ADDENDUM NO. 1

ISSUE DATE: **May 3, 2018**

RE: **Sterling Hall Renovation for TREX Physics**
University of Wisconsin-Madison
Madison, Wisconsin
UW-Madison Project No. **0057-1701**
UWSA Project No. **A-17-003**

FROM: KEE Architecture, Inc.
621 Williamson Street
Madison, Wisconsin 53703

Revisions:		
No.	Date:	Description:
△	05/03/2018	Addendum 1
Graphic Scale		
Project Numbers:	UWSA: A-17-003 MSN: 0057-1701	
Set Type:	BD	
Date Issued:	04/06/2018	
Sheet Number	A203

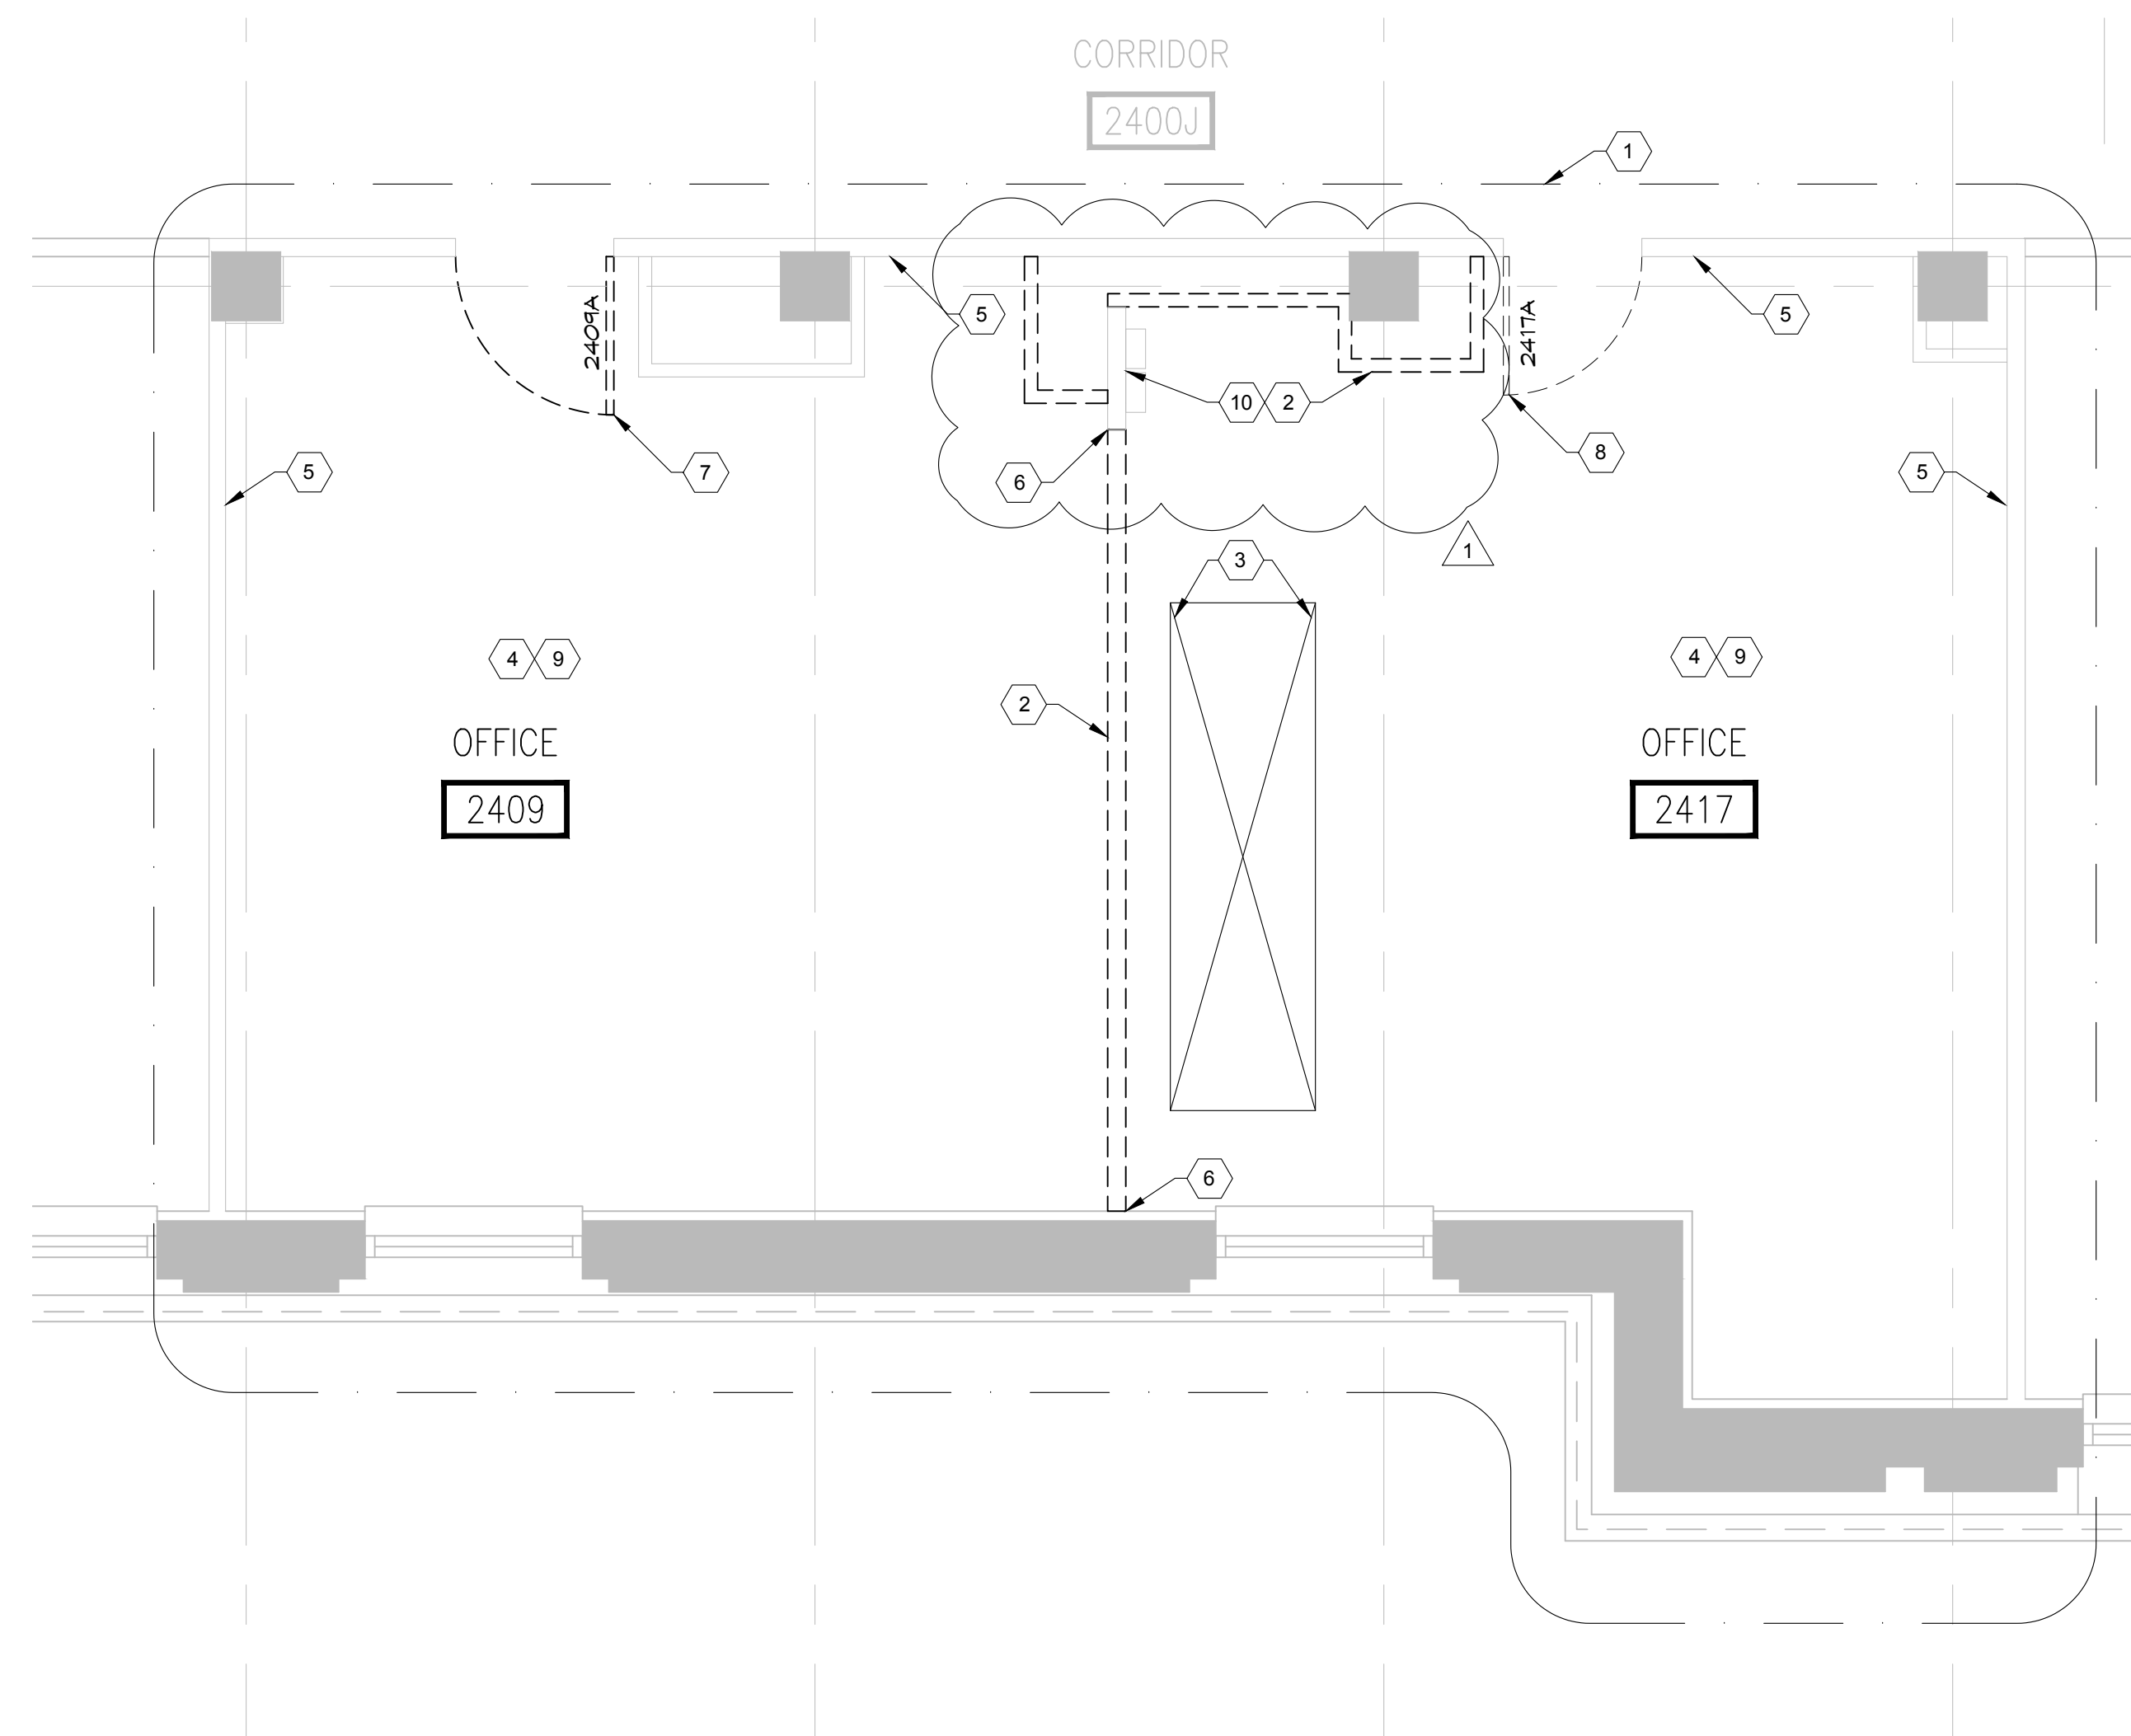
- a. Revised keynotes 3 and 4.
20. A203 – Partial Second Floor Plan (Demolition): Replaced sheet
 - a. Revised as indicated.
 - b. Revised keynotes 3, 6, and 10.

Sheet Title:
Partial Second Floor Plan

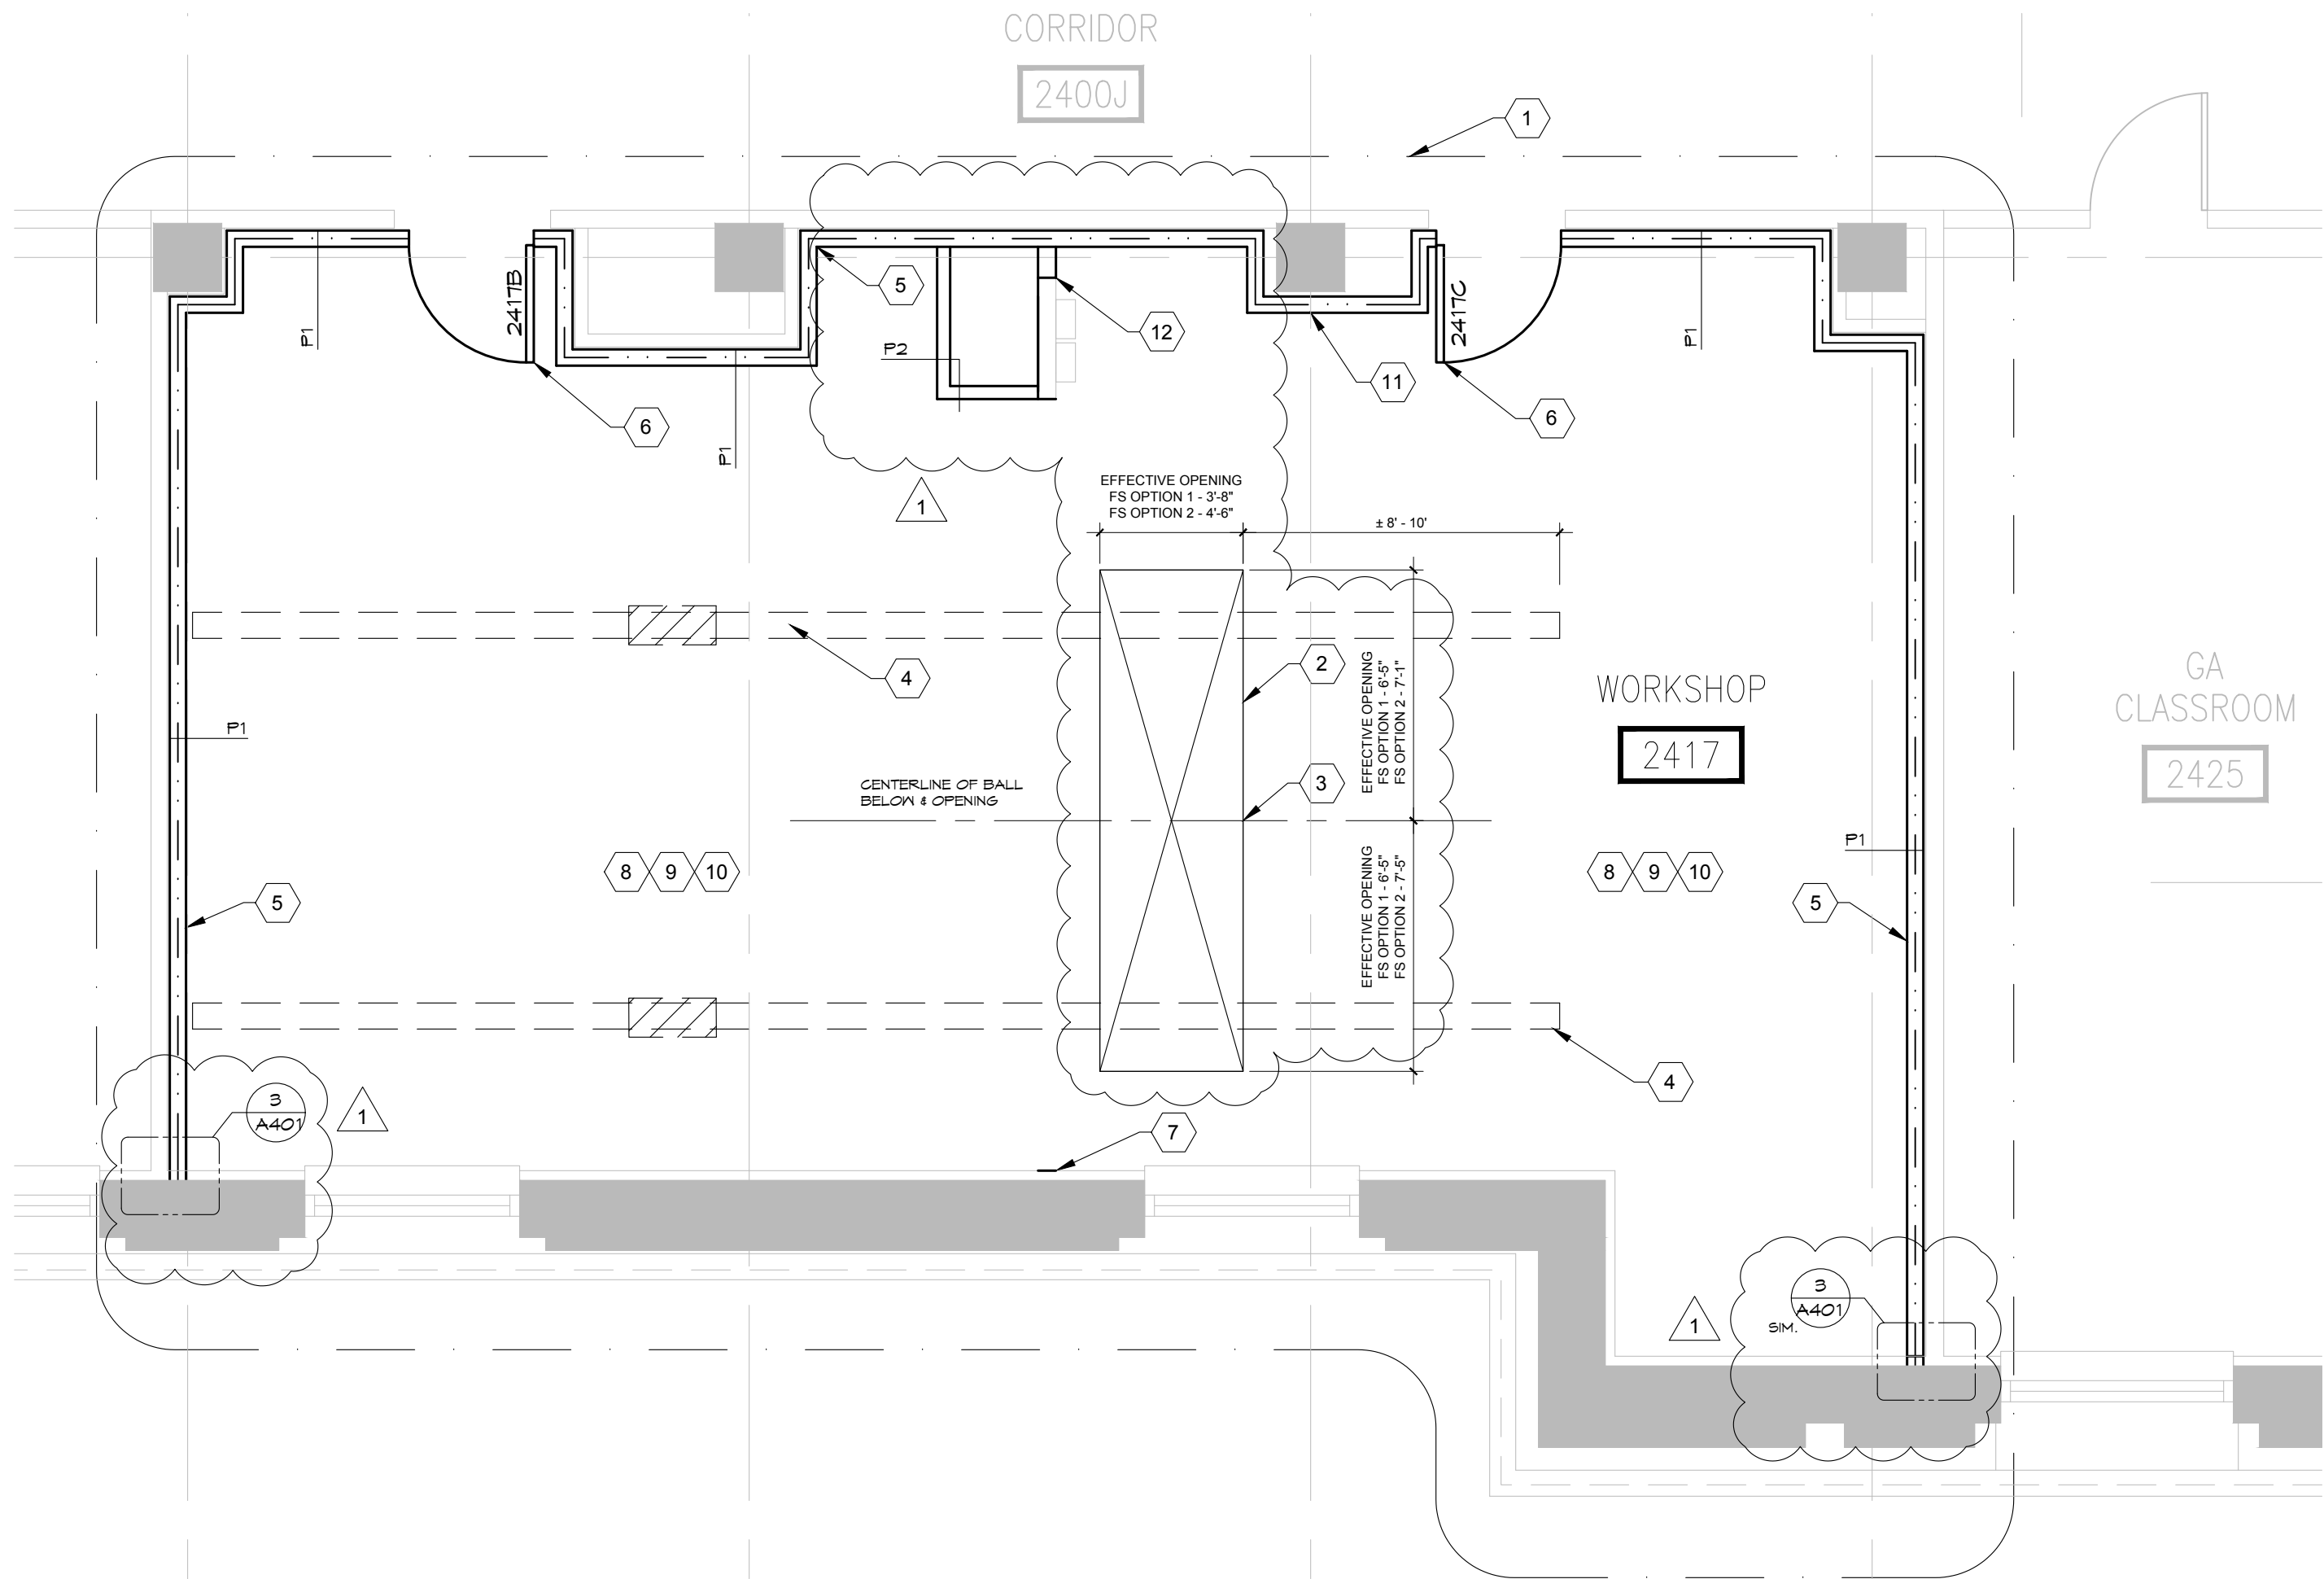
21. A302 – Partial Second Floor Plan: Replaced sheet
 - a. Revised partition location as indicated.
 - b. Added 2 callouts for wall details.
 - c. Revised keynotes 2, 4, and 12.

- d. Added Partition Type tags for clarity.
 - e. Added dimensions of floor opening as indicated.
22. A401 – Schedules & Details: Replaced sheet
 - a. Revised Partition Type P-1 detail.

3 REDUCED PRESS BACKFLOW PREVENTER DETAIL
P000 SCALE: NONE

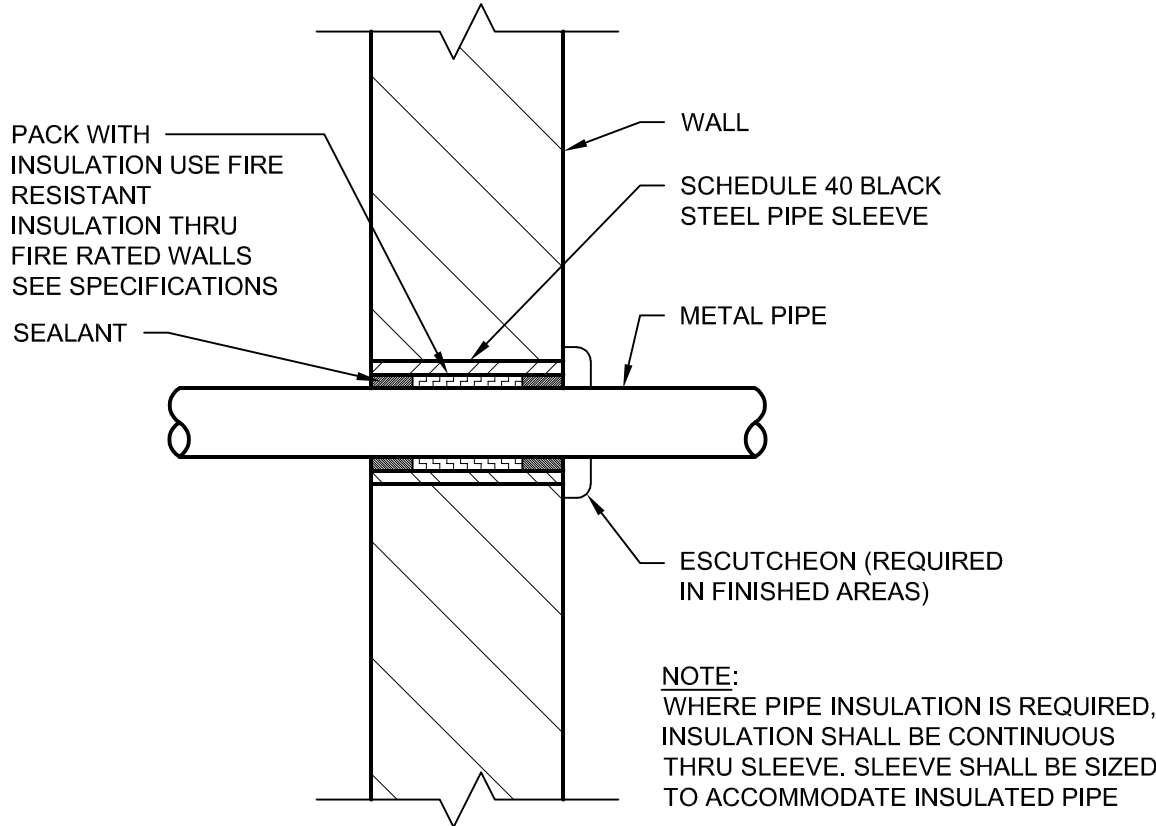
- 1 23. P000 – Symbols, Abbreviations, Details, and Schedules – Plumbing: Replaced sheet:
2 a. Added valves and check valves after each of the backflow preventers RBPB-1 and RBPB-2 as shown
3 on detail 3/P000.
4 b. Added location of conductivity meter on detail 4/P000.
5 c. Added solenoid valve and differential pressure sensors on DI inlet to chilled water system.
6 d. Revised RBPB and DI Unit schedules.
7
8 24. M100 – Partial Floor Plans - HVAC (Demolition): Replaced Sheet
9 a. Edited Keyed Note 8 To Read:
10 “HC Shall Coordinate All Demolition Activities With 23 09 14 Contractor. 23 09 14 Contractor (UW
11 Steam Fitter Shop) Shall Remove Existing Pneumatic Control Devices And Associated Control Lines
12 Back To Hall Way 2400J. Save Thermostat And Humidistat For Reuse Per M200.”
13
14 25. M200 - Partial Floor Plans – HVAC: Replaced Sheet
15 a. Edited Keyed note 7 to read:
16 “23 09 24 contractor (UW DDC shop) to provide new ddc controls within the existing control panel for
